GROWTH MANAGEMENT DEPARTMENT STAFF REPORT
VILANO BEACH TOWN CENTER OVERLAY DISTRICT

August 14, 2024 Public Meeting
VBTCDR 2024-07 Haley's Court

Summary of Request: Applicant is requesting design approval for improvements to the property located at 150 Vilano Road, known as Haley's Court. They are proposing changes that involve adding new parking spaces and associated landscaping.

PROPOSED SITE PLAN

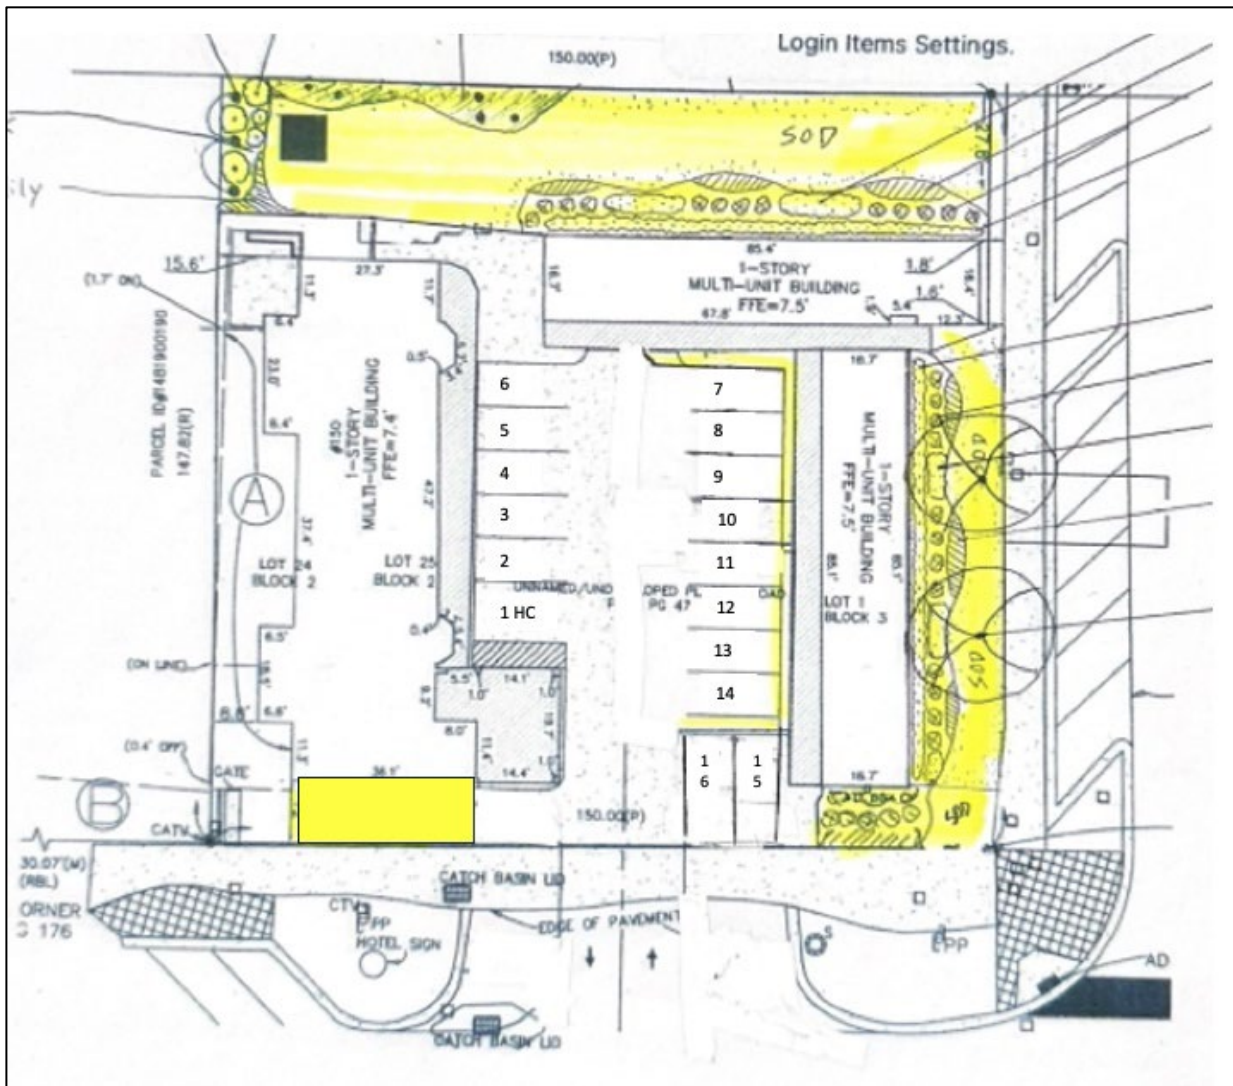
The applicant is intending to add parking spaces 7 through 14 as numbered on the plan above, spaces 1 to 6, 15, and 16 are already existing on the site. Those other areas marked with yellow are where they propose to add the new landscaping materials shown in the planning schedule that is also provided above.
